ERRATA SHEET

WRIR 86-4358 PLATE 3

HYDROGEOLOGY OF STRATIFIED-DRIFT AQUIFERS AND WATER QUALITY IN THE NASHUA REGIONAL PLANNING COMMISSION AREA
SOUTH-CENTRAL NEW HAMPSHIRE

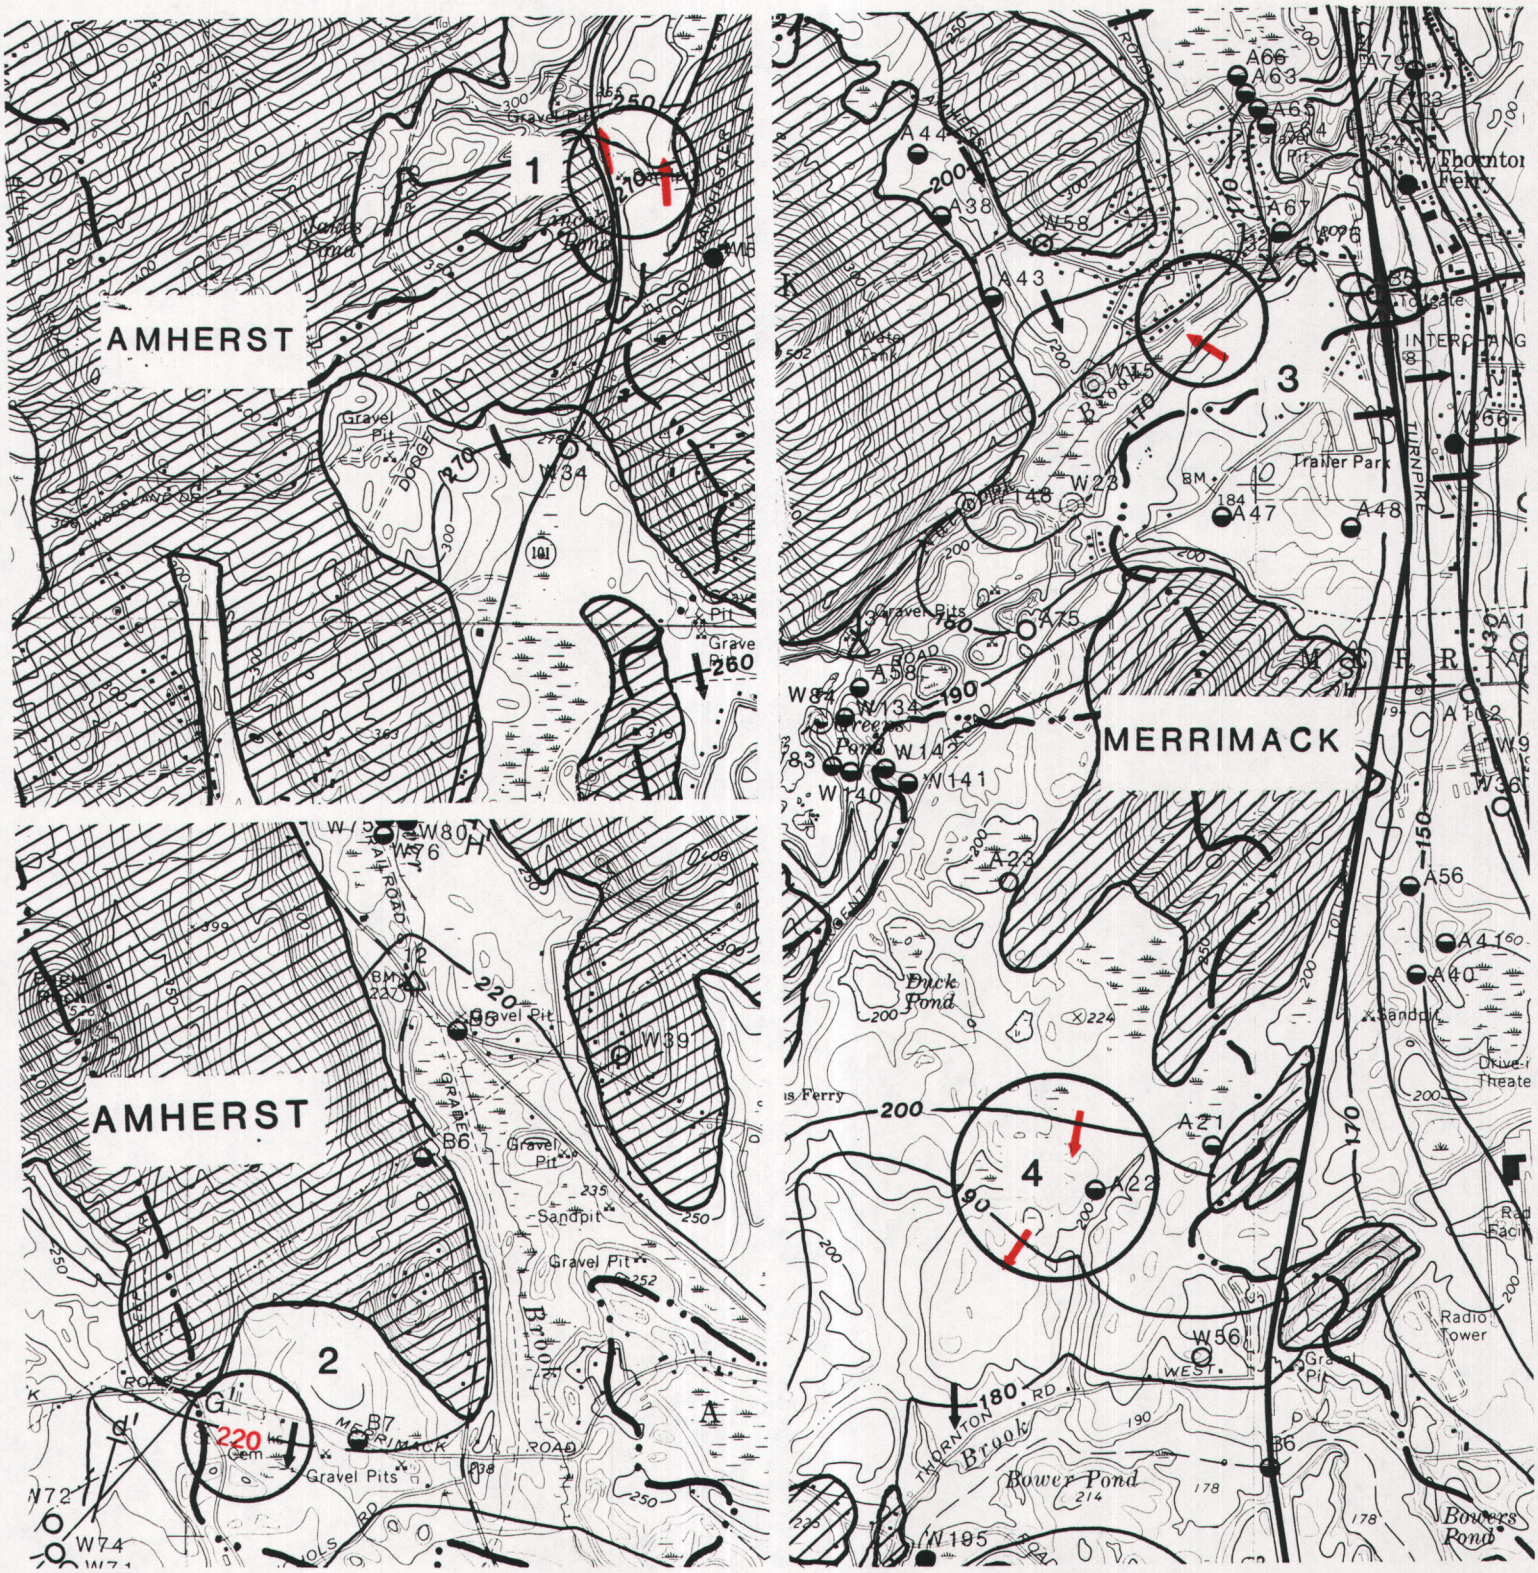
ERROR	TOWN	NEAREST LANDMARK	CORRECTION
1	Amherst	State Route 101/Lincoln Pond area	Flow arrows on water-table contours 260,270, opposite direction
2	Amherst	Merrimack Road/Nichols Road junction	Water-table contour 200 should be 220
3	Merrimack	Naticook Brook southwest of Thorntons Ferry	Flow arrow on water-table contour 170, opposite direction
4	Merrimack	Southeast of Duck Pond	Flow arrows on water-table contours 190, 200, opposite direction
